LUFTDYKTIGHETSPÅBUD (LDP)

MOTORDREVNE
LUFTFARTØY
MCDONNELL DOUGLAS
HELICOPTER- 54
(Forts. av HUGHES)

97-065 UTSKIFTING AV «TRANSMISSION OUTPUT DRIVE GEARS»

97-15-08 MCDONNELL DOUGLAS HELICOPTER SYSTEMS: Amendment 39-10081. Docket No. 97-SW-02-AD.

Figure 1. Contact Socket Inspection
PL AD 98-17-14

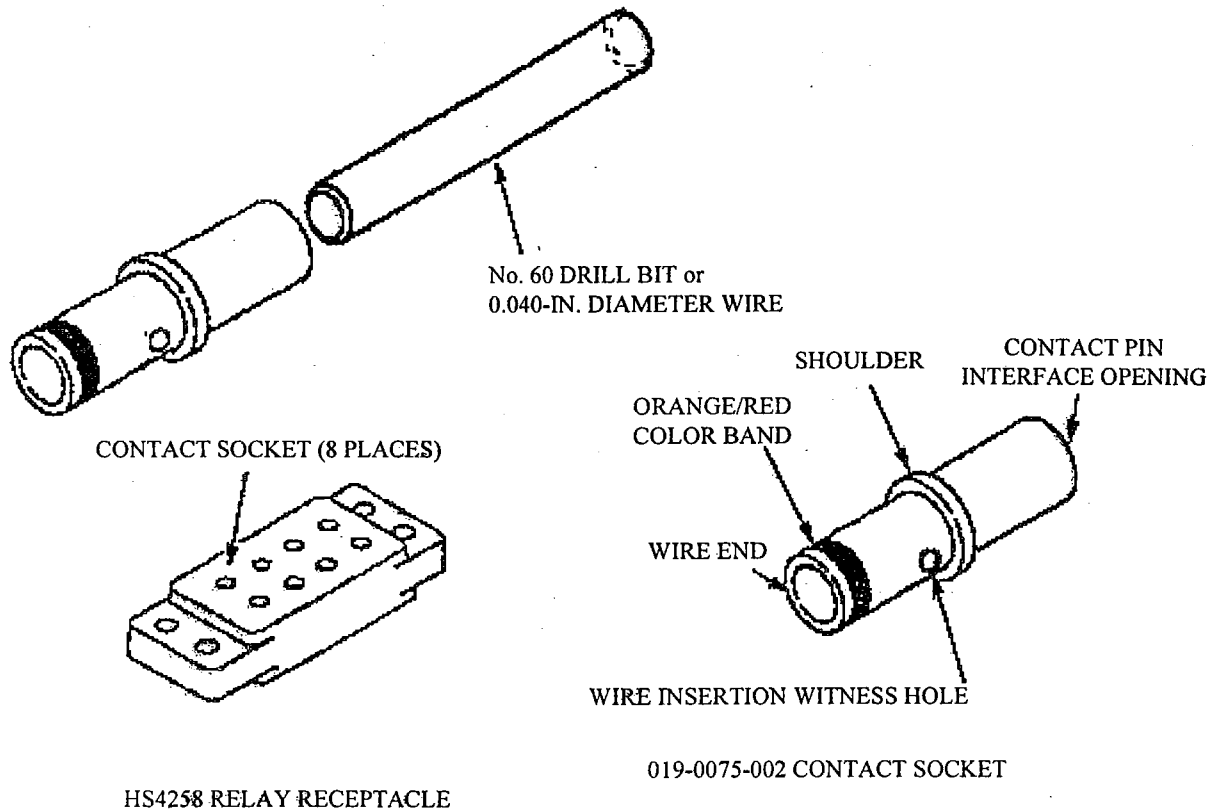
- (a) Access relays K1, K2, K3, K5, K104, and K200 (relays, part number (P/N) H4240).
- (b) Remove each relay specified in paragraph (a) from its relay receptacle (receptacle).
- (c) Using a No. 60 drill bit or a 0.040-in. diameter wire as a gauge, attempt to insert the gauge into every contact socket (socket) of each relay. Ensure the gauge is inserted perpendicular to the face of the receptacle, to prevent damage to the receptacle and the socket (Figure 1). If the gauge can be inserted into a socket, it is unairworthy and must be replaced with an airworthy socket, P/N 019-0075-002.
- (d) Any replacement relay, P/N H4240, must be inspected prior to further flight, in accordance with paragraph (c) of this AD.

Figure 1. Contact Socket Inspection
 AD 99-08-07

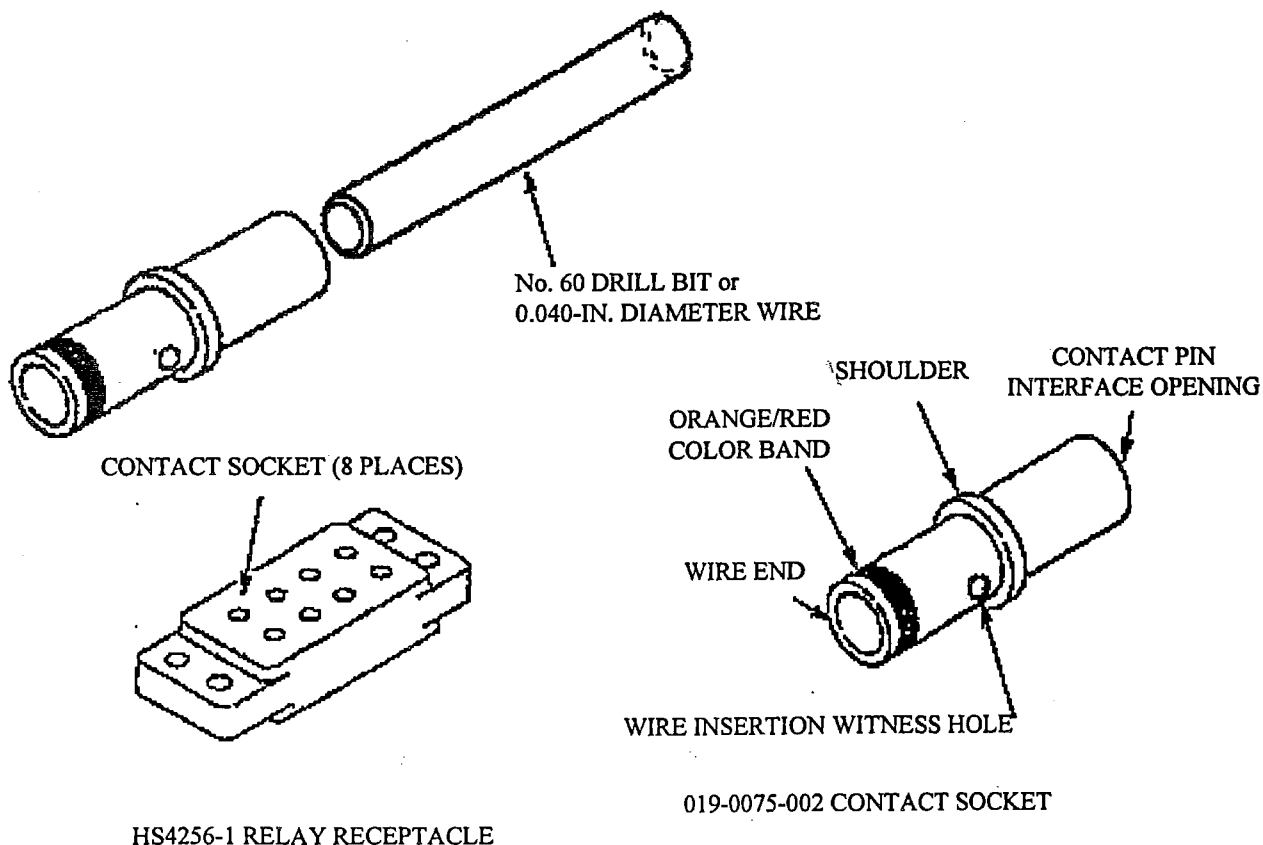
- Access relays K1, K2, K3, K5, K104, and K200 (relays, part number (P/N) HS4240).
- Remove each relay specified in paragraph (a) from its relay receptacle (receptacle), P/N HS4256-1.
- Using a No. 60 drill bit or a 0.040-in. diameter wire as a gauge, attempt to insert the gauge into every contact socket (socket) of each relay. Ensure the gauge is inserted perpendicular to the face of the receptacle, to prevent damage to the receptacle and the socket (Figure 1). If the gauge can be inserted into a socket, it is unairworthy and must be replaced with an airworthy socket, P/N 019-0075-002.

Figure 1. Fork Assembly with ridges (Sheet 1 of 2).

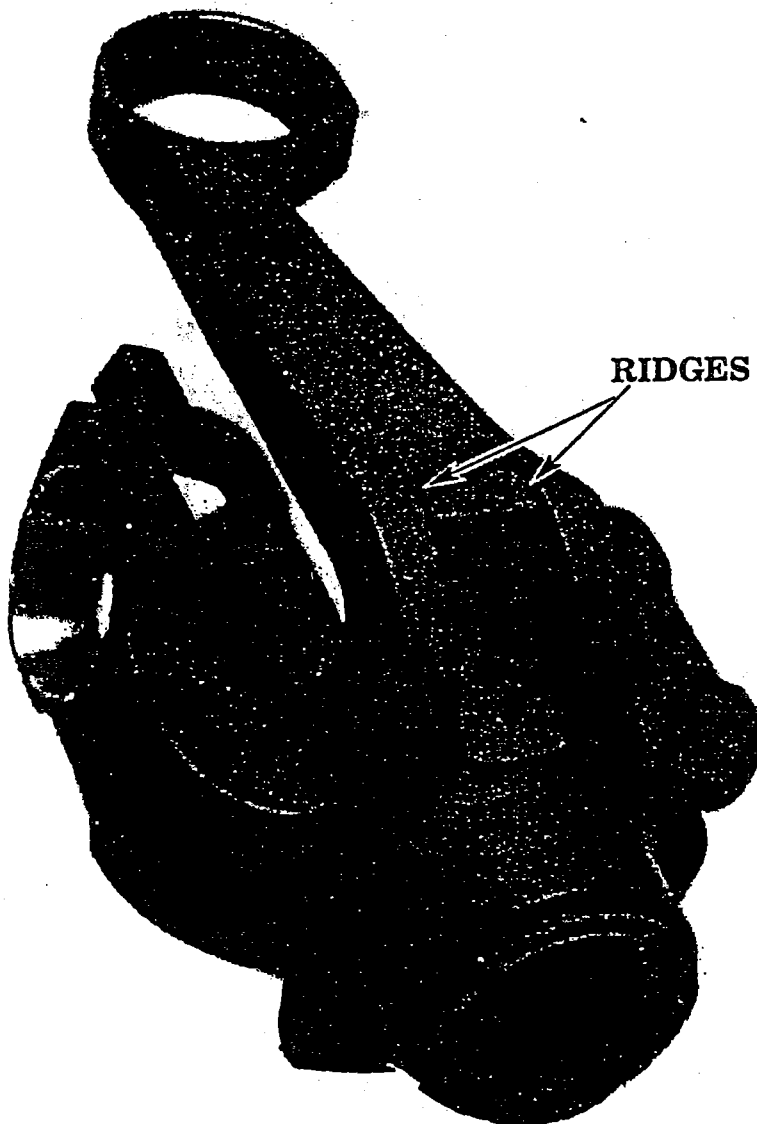
(a) Before further flight, inspect each fork assembly, P/N 369D21701-21, for the presence of ridges on the arms. See Figure 1, sheets 1 and 2.

(2) If no ridges are found, chemically remove paint from the machined areas, inspect the fork assembly for a crack using the dye-penetrant procedure of MIL-STD-6866 or ASTM-E1417, and conduct a visual inspection using a 10X or higher magnifying glass. (See Figure 1, sheets 1 and 2.) Replace a cracked fork assembly with an airworthy fork assembly. A fork assembly without ridges, P/N 369D21701-21, may not be installed.

Figure 1. Fork Assembly without ridges (Sheet 2 of 2).

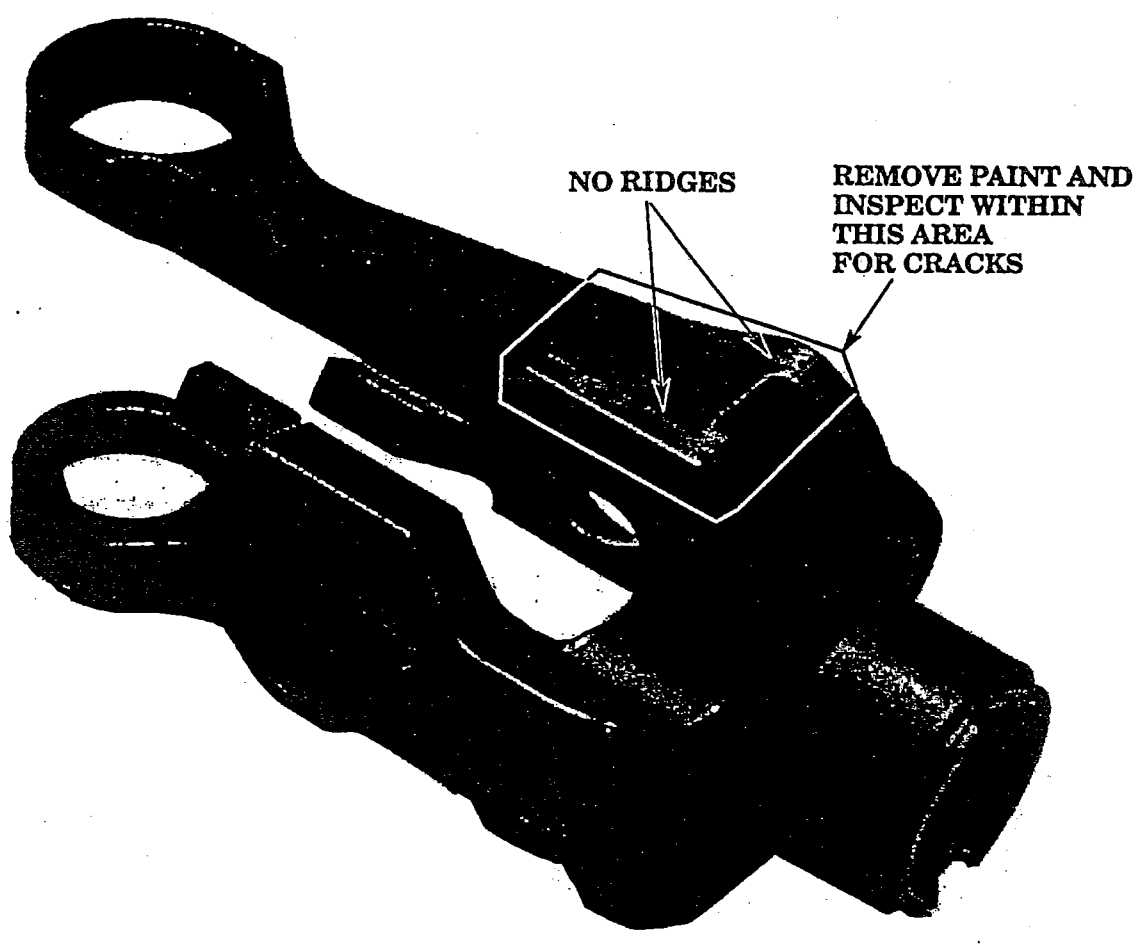
(b) Thereafter, at intervals not to exceed 50 hours time-in-service (TIS), visually inspect each fork assembly without ridges, P/N 369D21701-21, for a crack using a 10X or higher magnifying glass. (See Figure 1, sheets 1 and 2.) If a crack is found, replace the cracked fork assembly with an airworthy fork assembly. A fork assembly without ridges, P/N 369D21701-21, may not be installed.

Figure 1 - Inspection Location

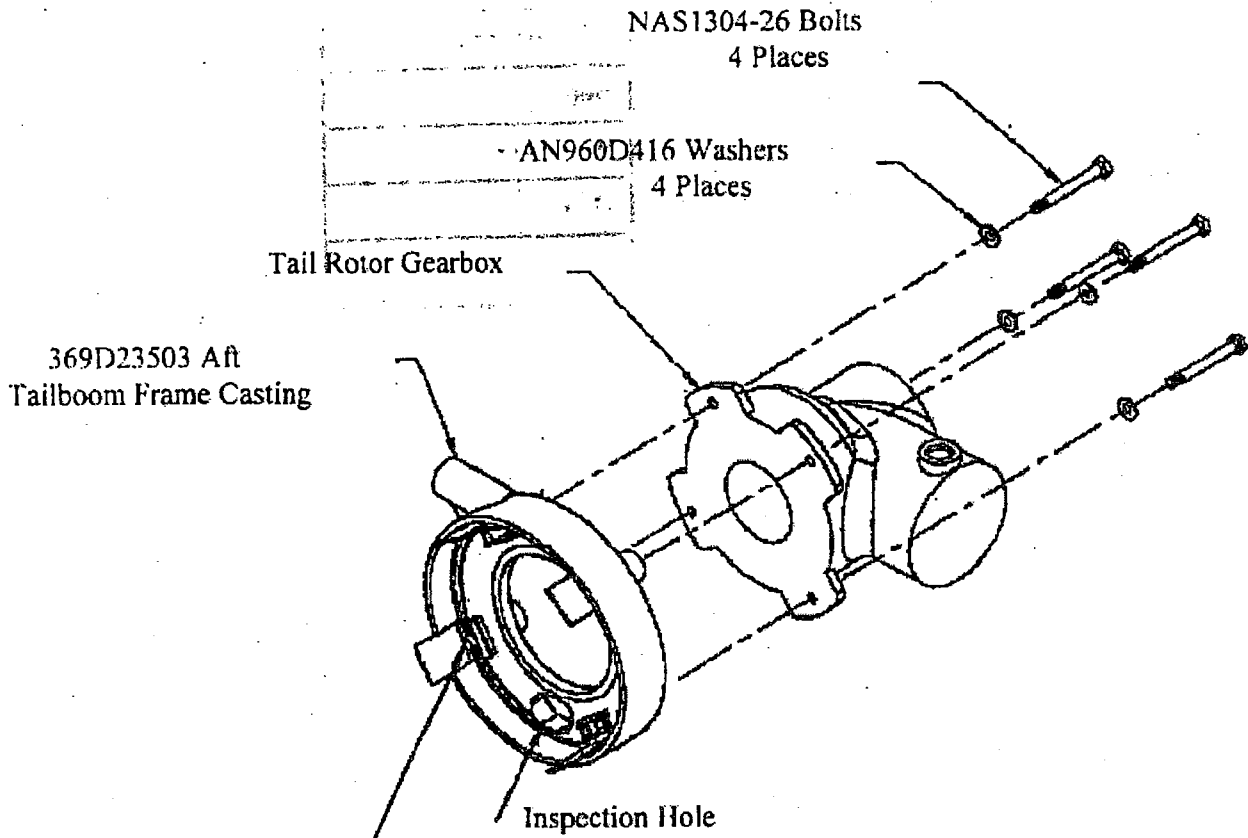
- (a) Within 25 hours time-in-service (TIS):
 - (1) For each tail rotor gearbox attaching bolt (bolt):
 - (i) Determine the part number (P/N).
 - (ii) If the P/N cannot be determined or if the bolt is not P/N NAS1304-26, before further flight, replace the bolt with bolt, P/N NAS1304-26.
 - (iii) Torque the bolt to 100-110 in-lbs and apply a slippage mark.
 - (2) Remove the tailboom control rod and determine the number of bolt threads protruding from each nutplate on the internal surface of the aft tailboom frame casting, P/N 369D23503, as shown in Figure 1 of this AD. At least one thread must protrude. If more than four threads protrude, add an additional washer, P/N AN960D416, under the bolt head. Torque the bolt to 100-110 in-lbs, and reapply a slippage mark. See Figure 1:

Inspect this area of each bolt.
 Bolt must protrude at least one
 thread past end of nutplate 4 places.

Figure 1. Tail Rotor Blade Assembly Inspection

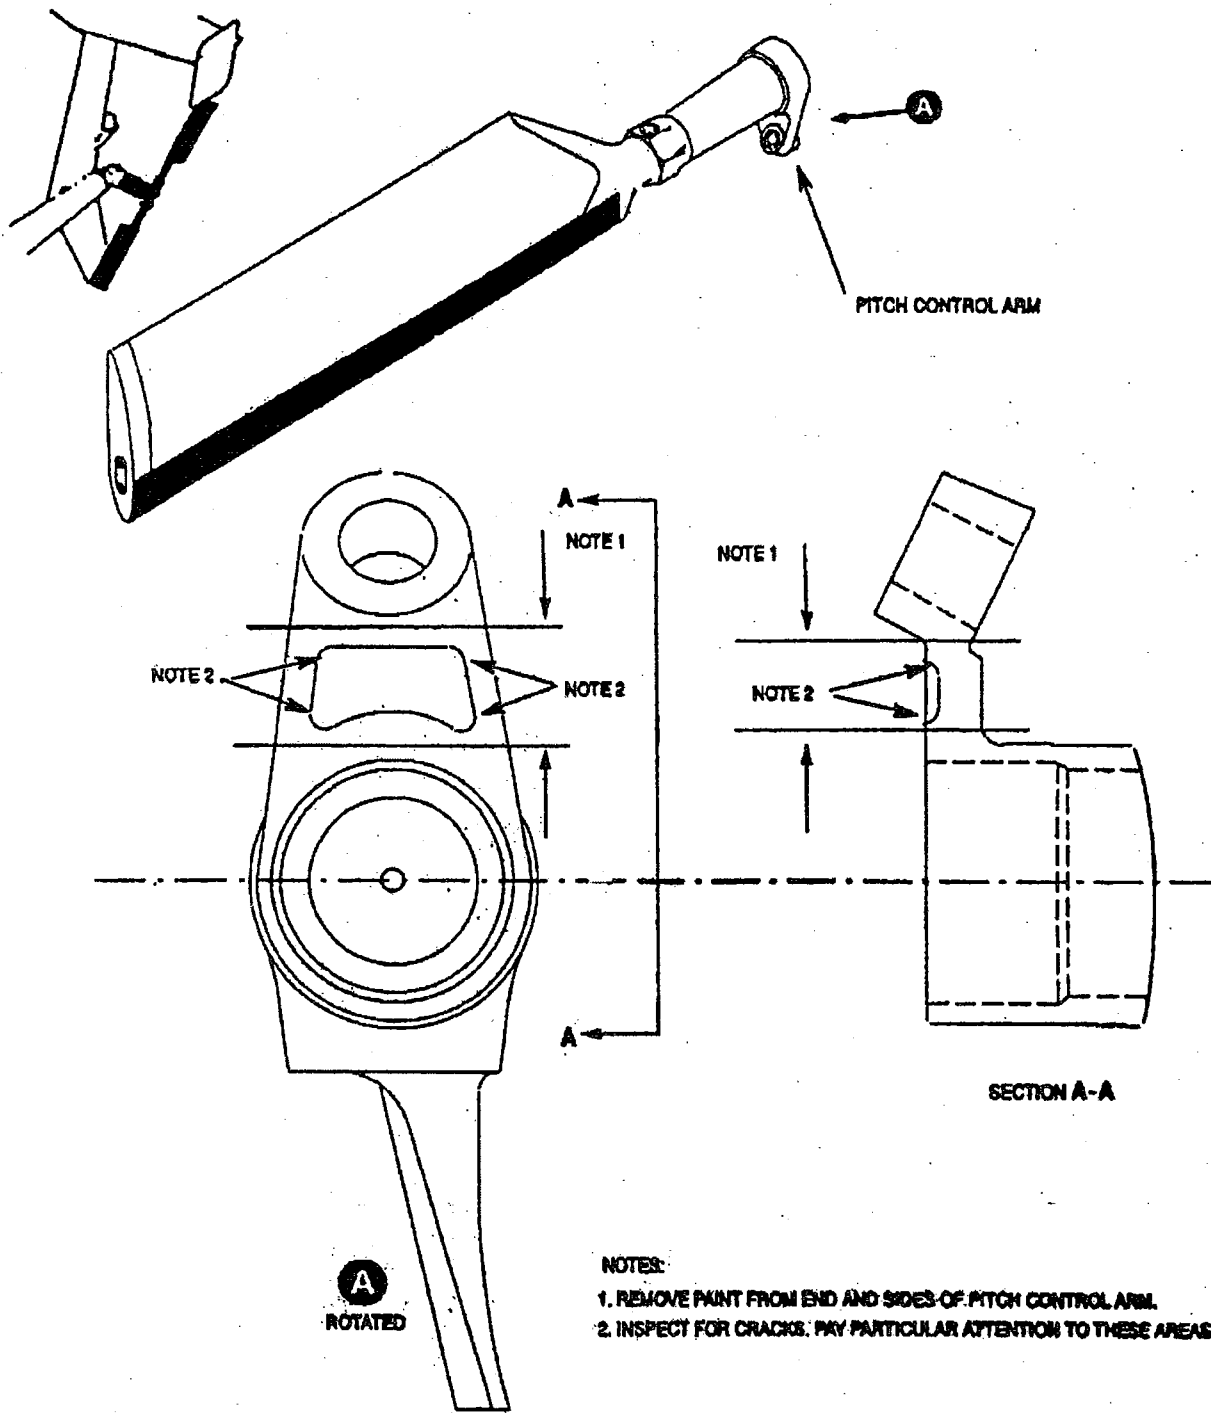
(b) Before further flight, perform a one-time visual inspection of each pitch horn for a crack or corrosion in the area indicated by Note 2 in Figure 1 of this AD. Paint removal in accordance with Note 1 of Figure 1 of this AD is not required for the visual inspection.
